## ST HELENA TUNNEL BLASTING WORKS

## TRIAL BLAST REPORT

Document Number: RPT-ENV-006 Rev 0

Report name	Pacific Highway Upgrade - Tintenbar to Ewingsdale – Proposed Blasting Modification			
Agency name	Environment Protection Authority			
Section	Comment	Adequacy	Merit	How addressed by RMS
		Tick where applicable

Figure 1 – Graph showing measured vibration levels as a function of the scaled distance term

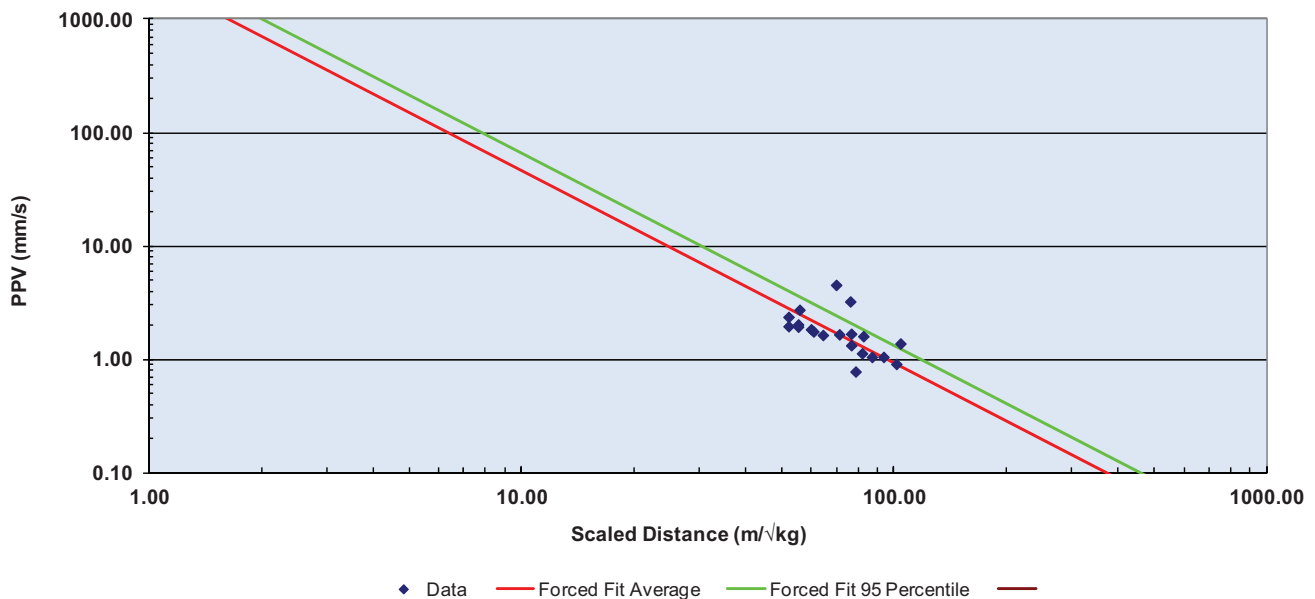
Figure 1 shows the recorded vibration data for each of the trials according to the production blast. The values on the Y axis indicate the measured vibration level (vector sum value). The values on the X axis represent the value of the scaled distance term, calculated as the distance between the blast and the monitoring site divided by the square root of the explosive quantity.

- The data are collected over a relatively narrow band of distances ranging only between 114 metres and 181 metres. Extrapolating beyond this range may provide erroneous results. Ideally, recording of some vibration levels nearer to the blast (say 50 metres) as well as information at further distances (say 250 metres) would assist in better defining the attenuation of vibration.
- The data indicate that the vibration levels measured at [REDACTED] are higher than expected when compared to the levels from the same blast recorded at the other properties. As

an example, for the third blast a level of 4.54mm/s was measured at the [REDACTED] property at 153 metres from the blast whilst at the closer [REDACTED] property which was 131 metres from the same blast, the levels was less than half at 1.84mm/s. The [REDACTED] results all show similar cases of measuring higher vibration levels when compared to other closer points from the blast.
